**DRAFT INDIVIDUAL ENVIRONMENTAL REPORT  
SUPPLEMENTAL**

**IMPROVED PROTECTION ON THE INNER HARBOR NAVIGATION  
CANAL**

**IER # 11 TIER 2 BORGNE SUPPLEMENTAL**

October 2009

Figure 2: Conceptual plan for Bayou Bienvenue vertical lift gate in open position

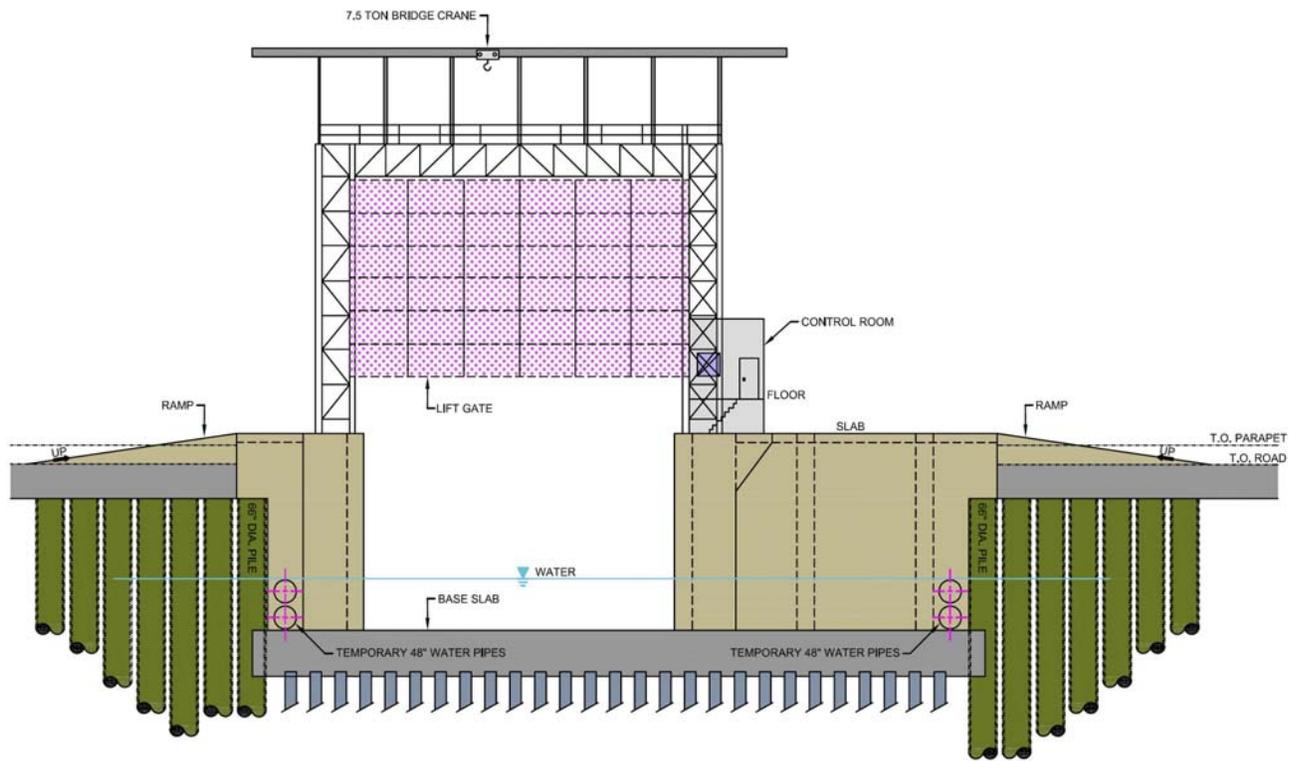
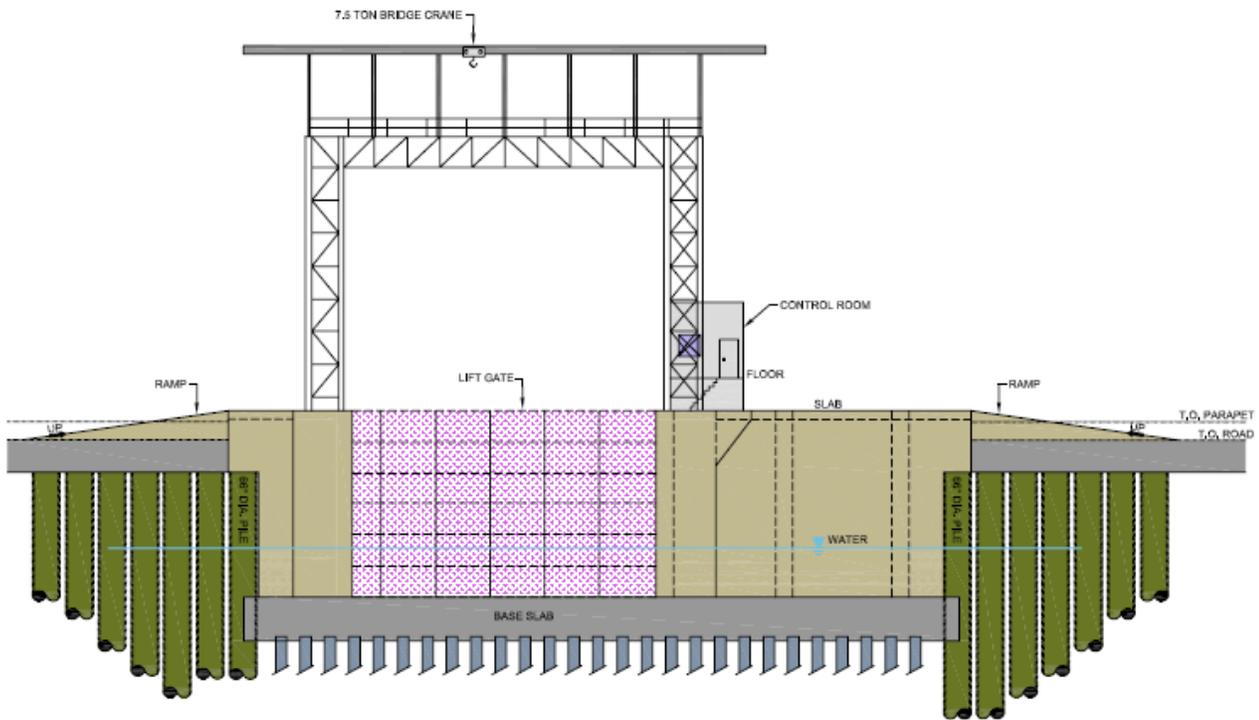
A vertical lift gate consisting of a steel trussed gate operated by winch systems and supported by two structural steel towers and a steel trussed span over the gate and channel (figures 2 and 3) would be constructed where the Borgne Barrier crosses Bayou Bienvenue. The structure would also include an independent vehicular lift bridge system (approximately 12 feet wide by 58 feet long), located on the protected side of the lift gate to provide access as needed to cross the 56 feet wide channel, without the need to lower the gate. The lift bridge would be supported by the tower structure and operated by winch systems (figure 4).

Figure 5: Bayou Bienvenue vertical lift gate and bridge complex in plan view

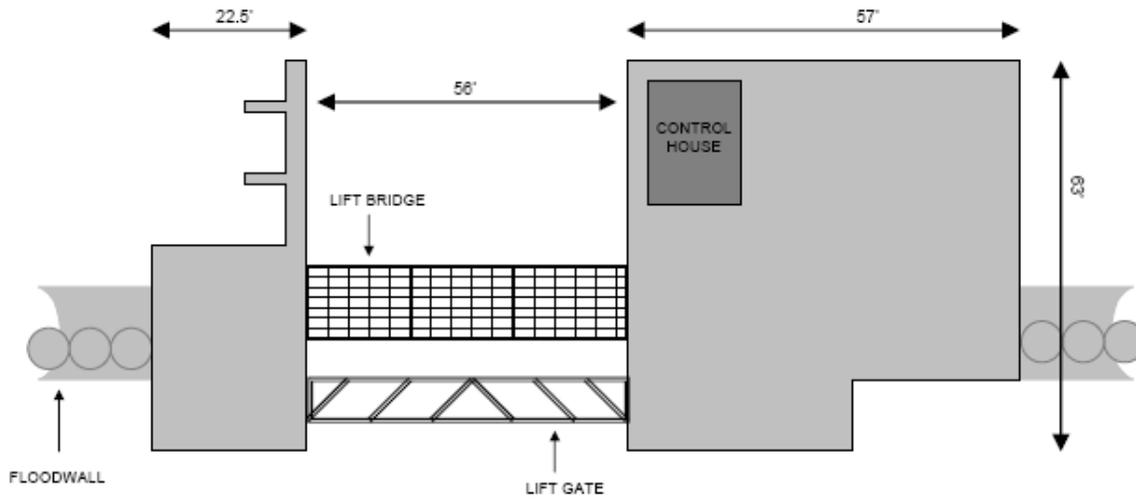
The structural steel towers would be supported by two concrete abutments on either side of the channel. A concrete monolith adjacent to the gate could provide access to the towers, a generator and control facility, fuel storage tank, vehicular parking and adequate space for a truck turnaround (figure 5). The concrete monolith foundation would be a pile supported base slab at sill elevation -8.00 feet. To allow navigation, the lift gate and bridge would provide 35 feet of vertical clearance in the raised position from a water elevation of +1.0 foot [North American Vertical Datum (2004.65) (NAVD88)]. The currently approved plan has no vertical clearance restrictions.
